Vieux Carré Commission Architecture Committee Meeting

Tuesday, February 9, 2021

VCC Architectural Committee

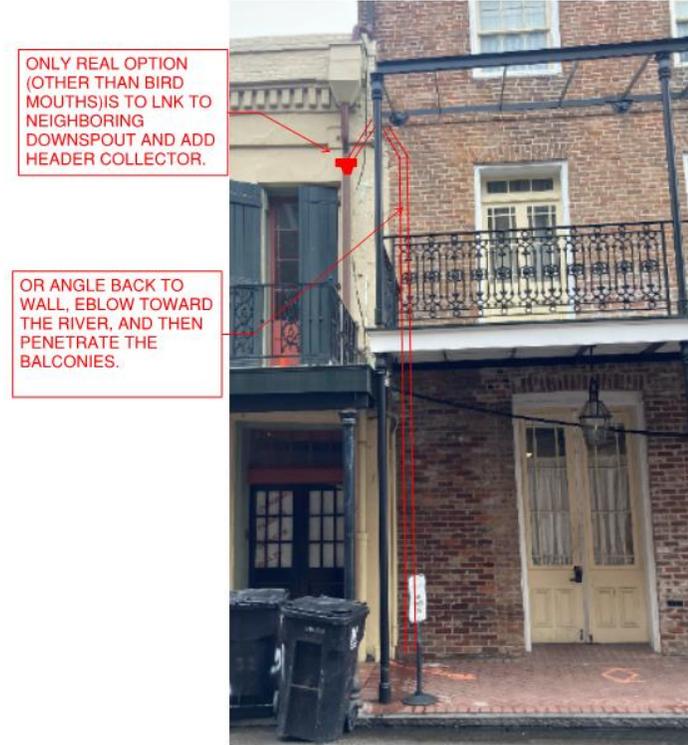
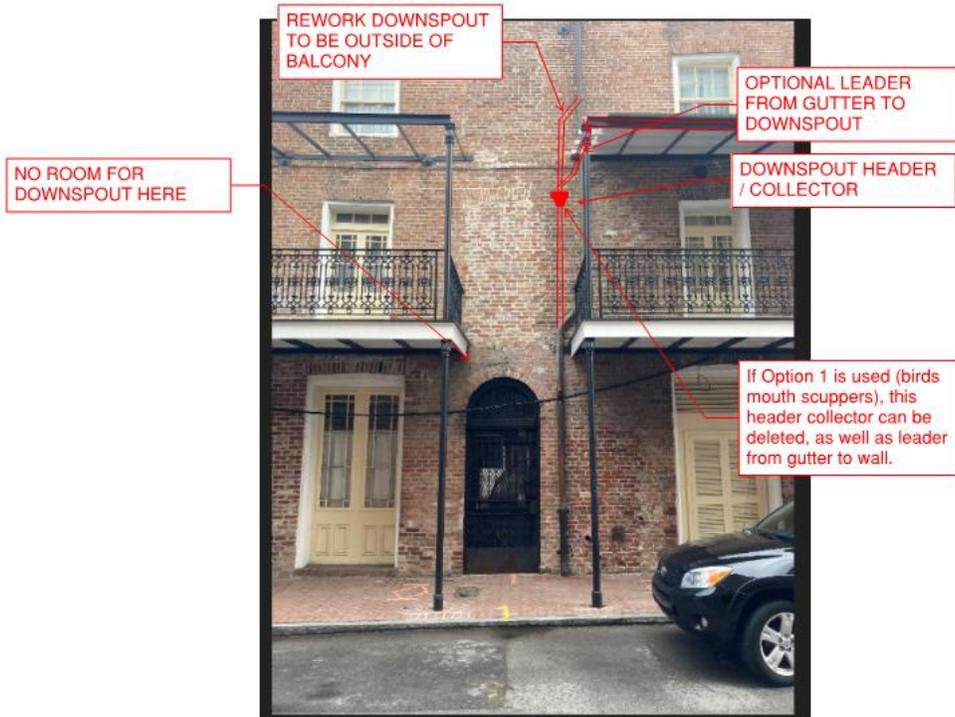
DECATUR STREET -
DOWNRIVER EDGE
NO DOWNSPOUT. BIRDS
MOUTH SCUPPERS AT END,
MIDDLE, AND AT CENTER OF
RADIUS AT CORNER

DECATUR STREET -
DOWNRIVER EDGE
OPTION 2 - ANGLE BACK TO
WALL, NEW DOWNSPOUT
(POTENTIAL CONFLICT WITH
ADJACENT COLUMN.

conflict with either column
or electric service

OPTION 1 (NOT SHOWN) - BIRDS MOUTH SCUPPERS AT EACH END OF LAKESIDE GUTTER; END AND MIDDLE (AND CORNER AT RADIUS) OF RIVERSIDE GUTTER.

③ FIRST FLOOR PLAN - REV. 2.1.21
1/4" = 1'-0"

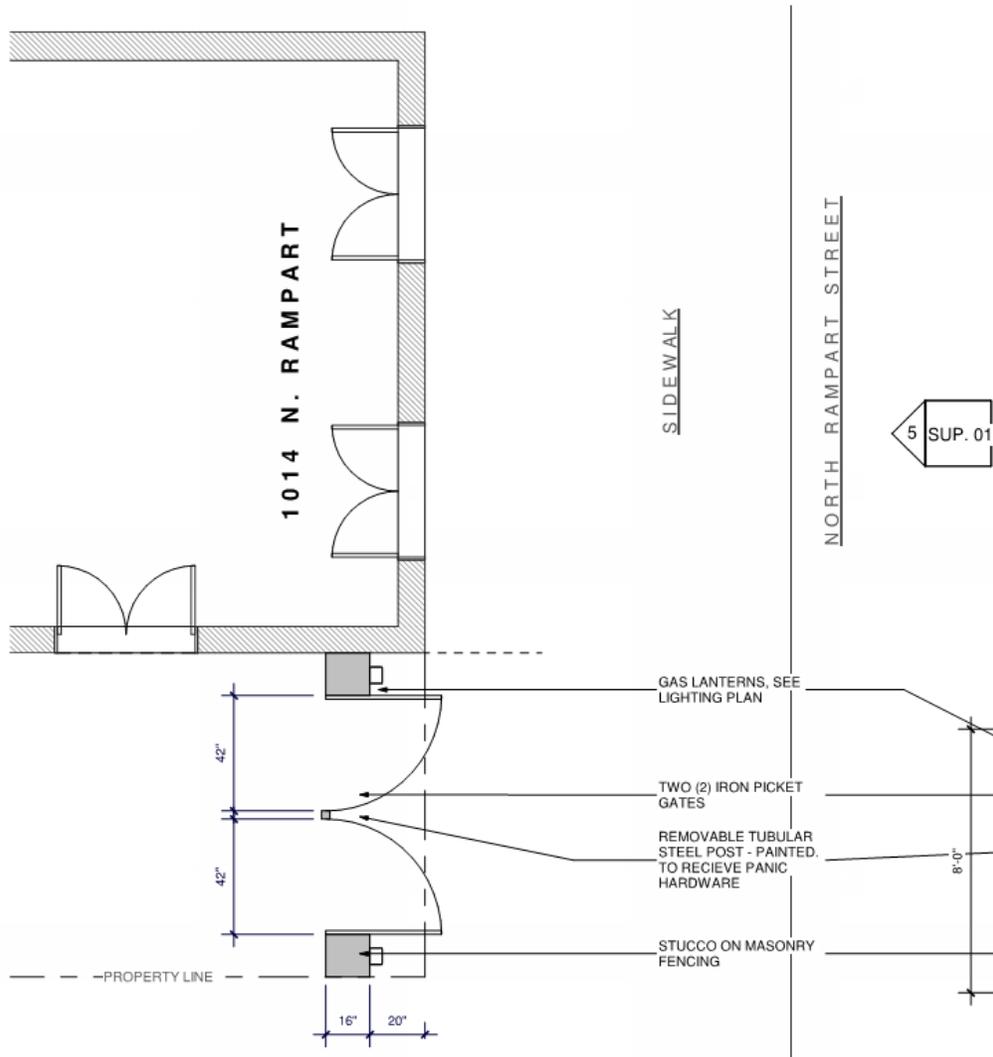
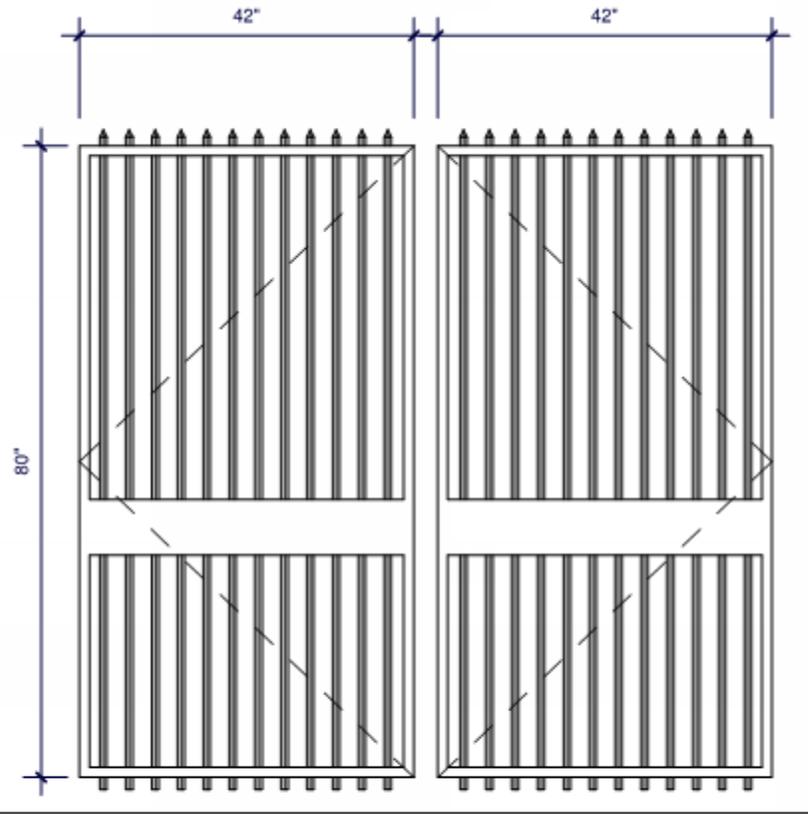
3 FIRST FLOOR PLAN - REV. 2.1.21
1/4" = 1'-0"

4 N. RAMPART ELEVATION - REV. 2.1.21
1/4" = 1'-0"

Proposed Gate Design

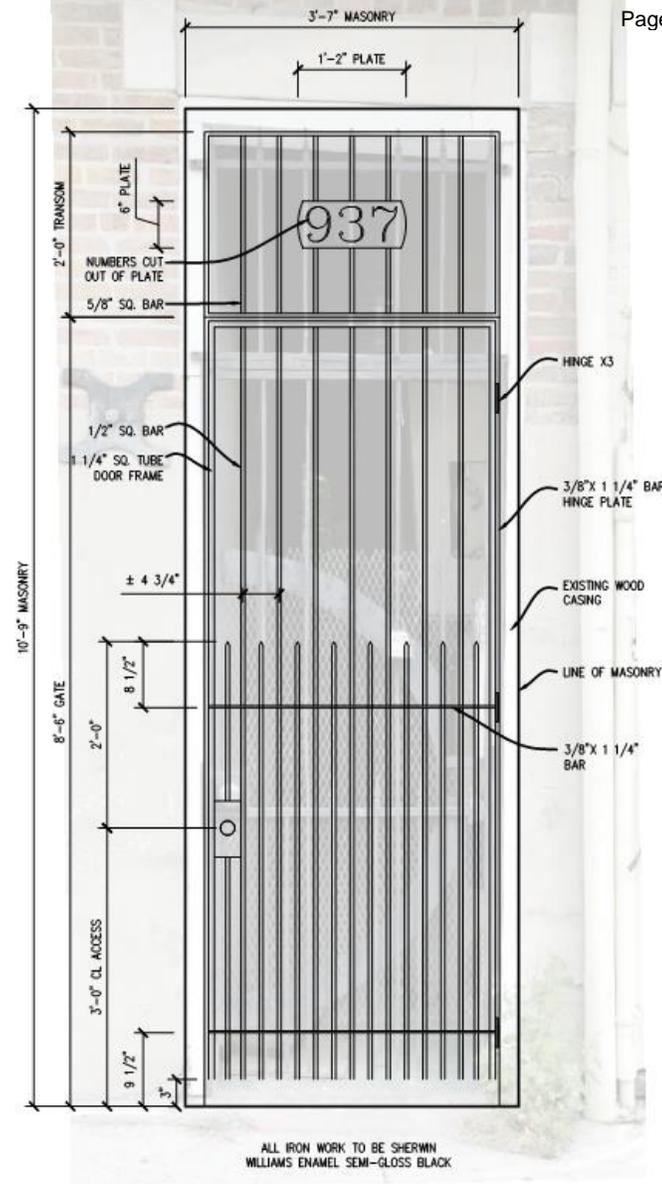
937 Dumaine St. Existing
Existing outward swing iron security gate. The opening is approx 10' 6" high and 43" wide to the masonry. The wood framing creates about a 2 to 3" border.

Solid iron gate and transom concept common to the French Quarter. 5/8" bar set on diamond pattern in 3/8" flatiron with classic lockset with matching transom. All solid material to be built by Darryl Reeves of Andrew's Blacksmith Shop in NO.

It will be heavy gauged to match other iron generally found in the FQ with heavy hinges and hardware. To avoid the use of expanded metal around the lockset to prevent unauthorized access from the exterior, we plan to use an additional picket between each main bar up to 58" with pointed tops.

Classic large gauge brass knob hardware and iron plated mortice latch around knob area have been suggested to prevent access to the internal knob from the exterior and will be added. Per Fire Marshall requirements, the interior knob will be practical to unlock gate from interior.
